**BEFORE THE PUBLIC UTILITY COMMISSION
OF OREGON**

Docket No. LC 76

CASCADE NATURAL GAS CORPORATION,

Staff's Final Comments

Figure 1: Bend Loop Residential Use-per-Customer

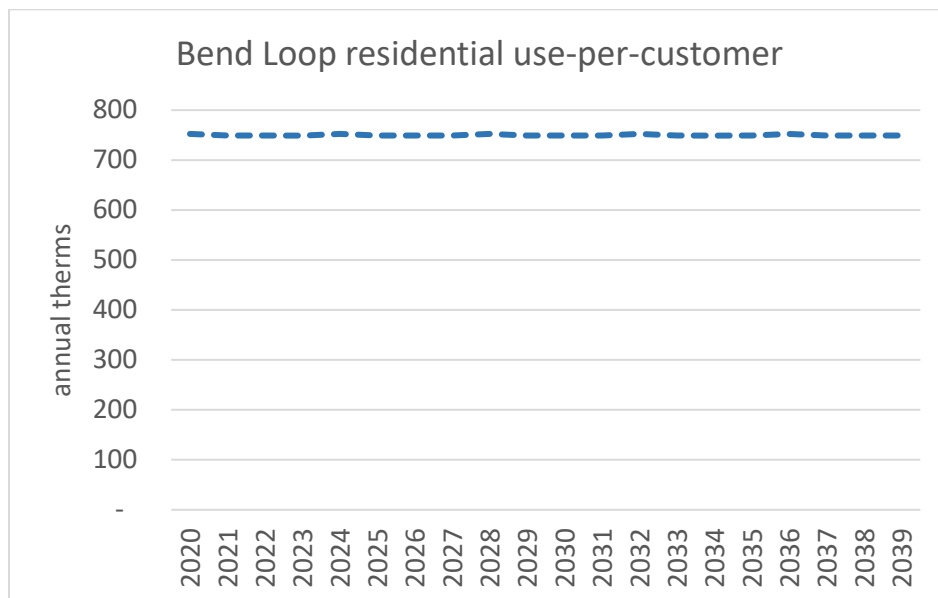
CUB also requested that the Company conduct sensitivities to gas use-per-customer (UPC) dependent on the adoption of high efficiency furnaces. Staff supports CUB's recommendation. For example, *Figure 1* below shows that in the Company's expected case forecast, Bend Loop residential UPC is nearly constant over time.⁴

The Company forecasted that residential customers in Bend, Oregon will continue to use about 750 therms per year during the entire forecast horizon of 2020 to 2039. Staff agrees with CUB that the Company should conduct a sensitivity or scenario where UPC falls over time due to the adoption of high efficiency furnaces.

- Provide its demand forecast workpapers with its initial filing of the next IRP.
- Include price as an explanatory variable in its demand forecast.
- Publish variables included in the model as part of an appendix.
- Conduct a sensitivity or scenario where UPC falls over time due to the adoption of high efficiency furnaces.

Figure 2: Avoided Cost Comparisons

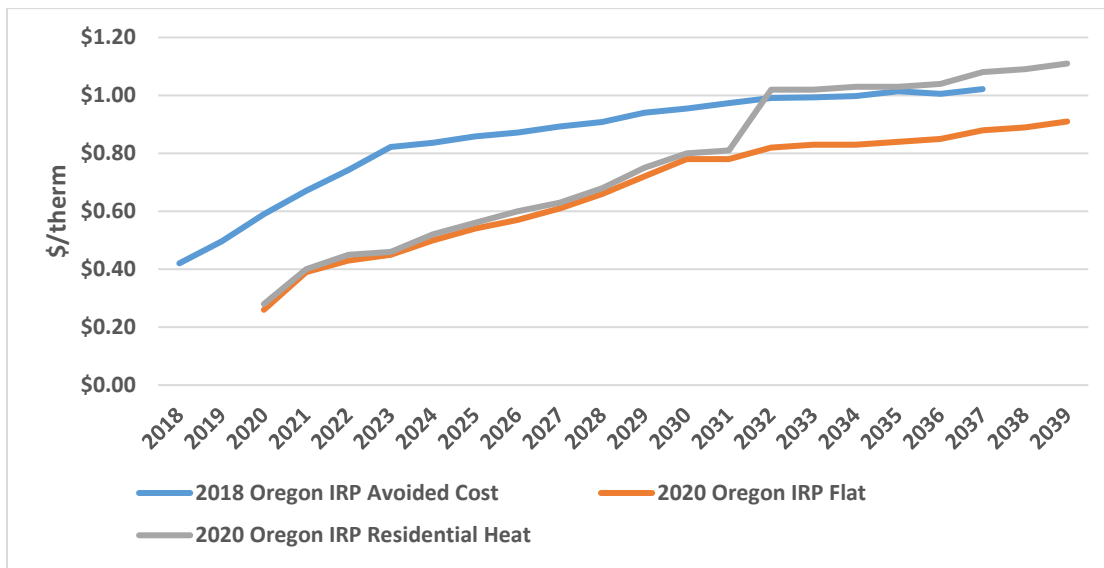
Figure 2 compares the 2018 IRP avoided cost for Oregon and two example end uses from the 2020 IRP. Several of the avoided costs of the other end uses are very similar to each other and would visually overlap on the graph. Residential heating and commercial heating had nearly identical costs, so only “Residential Heat” is shown as an example. The “Flat” end use line represents the other end uses that have less of an impact on peaks. In earlier years, avoided costs in the 2020 IRP are half the values of the 2018 IRP. In later years, flatter end uses remain 20 percent below 2018 IRP values, and starting in 2032, residential heating reaches values similar to those found in the 2018 IRP. Notably, 2032 is the year the Company identified a shortfall in transport capacity. While this cost is shared by all end uses, there is a greater avoided cost associated with heating because of its contribution to peak usage.

The Company explained that the reduction in avoided costs as compared to the 2018 IRP was largely driven by lower gas prices. In the time following this forecast, the Company has provided an updated natural gas price forecast, which will be used in 2021 for the next round of avoided cost calculations in UM 1893.⁹ This updated gas price forecast is slightly higher than the forecast used by the Company for the initial avoided cost calculation. If the new forecast is used, it would result in a slightly higher avoided cost, particularly for energy efficiency measures that have longer lives.

It is important to note that the avoided costs as presented in the 2018 IRP were not the final numbers used for avoided costs in UM 1893, which has its own process to determine which values to use. Additionally, while the Company calculated avoided costs by end use for the IRP, Energy Trust makes its own calculations independently to estimate values across energy efficiency end uses. In a preliminary analysis provided to Staff by Energy Trust comparing results from data approved for UM 1893 use in 2020 to the data provided in the Company's 2020 IRP, the impact is a reduction of three to eight percent depending on the end use.
